ADDENDUM 01

Addendum to the drawings and specifications for:
Kendall County – Emergency Medical Services Station No. 3

EMERGENCY MEDICAL SERVICES STATION NO.3

10.06.23

4 CW ENTRY DETAIL
NOT TO SCALE

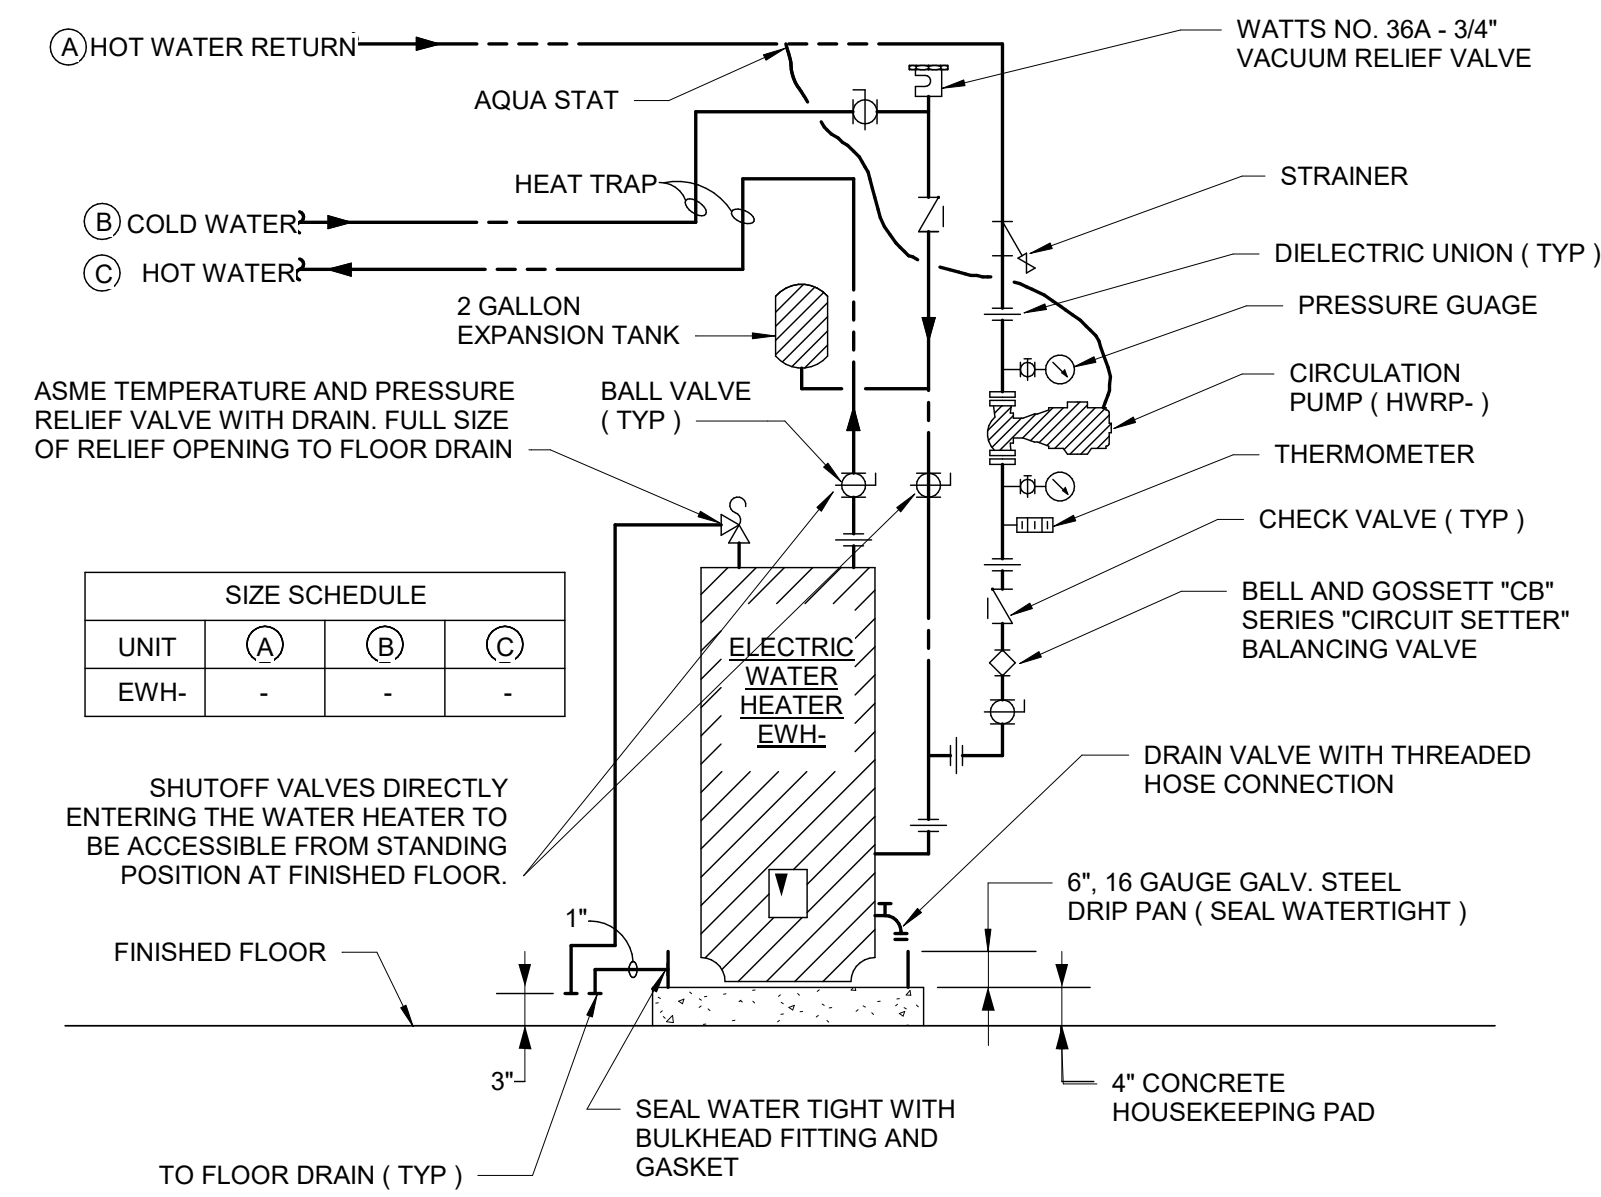
- Item 1: Revised detail #4 to remove pressure tank from water entry detail.

- Item 1: Revised detail #4 to remove pressure tank from water entry detail.

3 PLUMBING ISOMETRICS

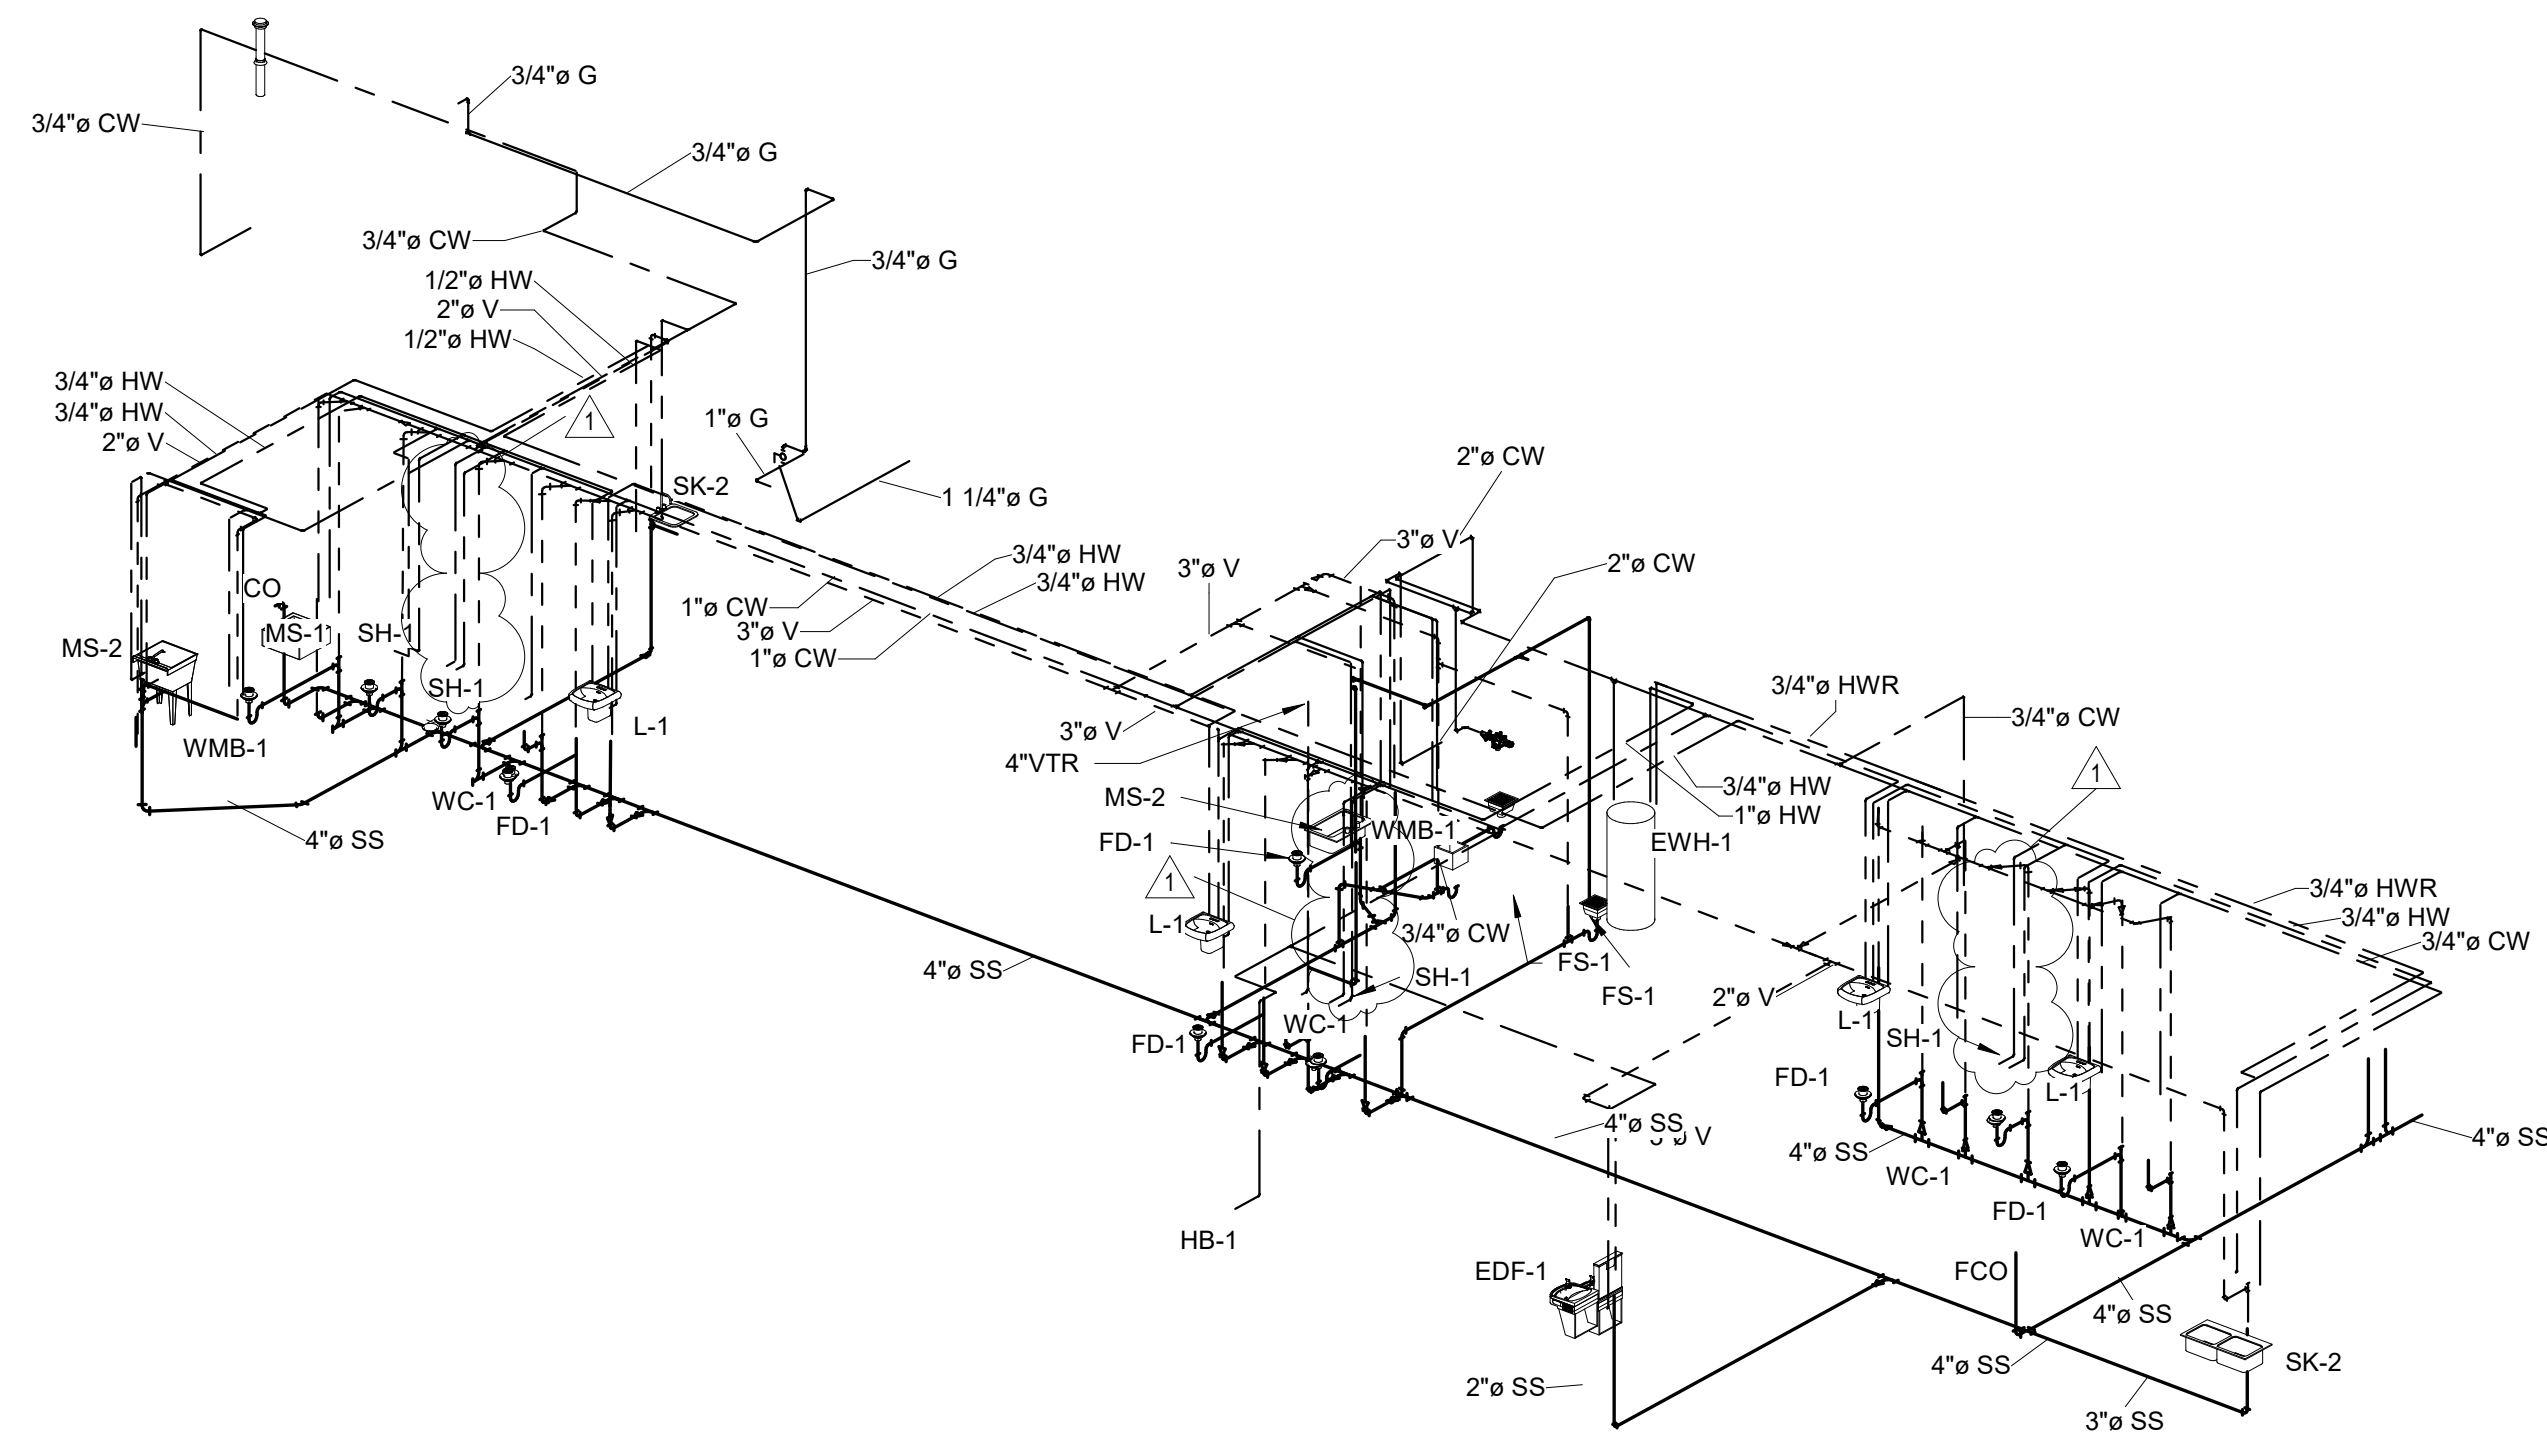
- Item 1: Revised detail#3 Plumbing Isometrics per plumbing revisions noted above.

- Item 1: Revised detail#3 Plumbing Isometrics per plumbing revisions noted above.
